Well Name: PURE GOLD MDP1 29-17 FED COM	Well Location: T23S / R31E / SEC 29 / SESW / 32.2693599 / -103.8001556	County or Parish/State: EDDY / NM
Well Number: 173H	Type of Well: OIL WELL	Allottee or Tribe Name:
Lease Number: NMNM0545035	Unit or CA Name:	Unit or CA Number:
US Well Number: 300154571800X1	Well Status: Drilling Well	Operator: OXY USA INCORPORATED

Notice of Intent

Sundry ID: 2640167

Procedure Description: OXY USA Inc. respectfully requests approval to amend the approved APD directional, casing, cementing and mud programs. See the attached directional plan and drill plan for reference. Also note the HSU and well spacing change on the C102 well plat attached.

Figure C] 4 – String – Un Cemented Annulus

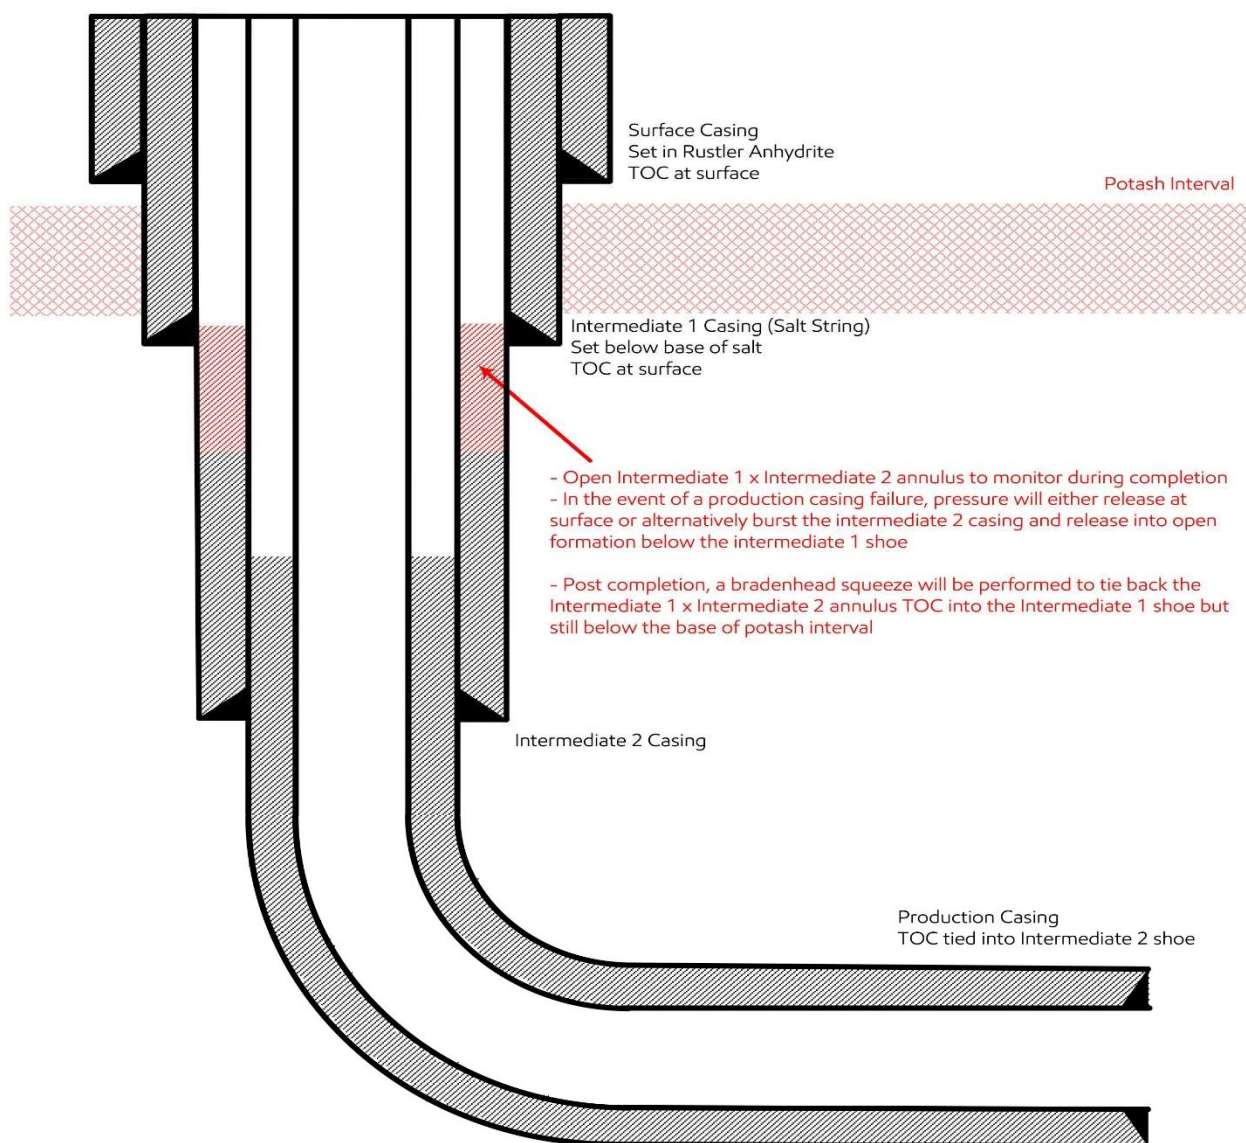
Operator has proposed to pump down the 9-5/8" X 7-5/8" annulus post completion. Operator must run Echo-meter to verify Cement Slurry top in the annulus. Submit results to the BLM. No displacement fluid shall be utilized at top of the cement slurry.

Operator has proposed an open annulus completion in R111P. Operator shall provide a method of verification pre-completion top of cement. Submit results to the BLM. Pressure monitoring device and Pressure Safety Valves shall be installed at surface on both the 7-5/8" X 9-5/8" annulus and the 9-5/8" X 5-1/2" annulus for the life of the well.
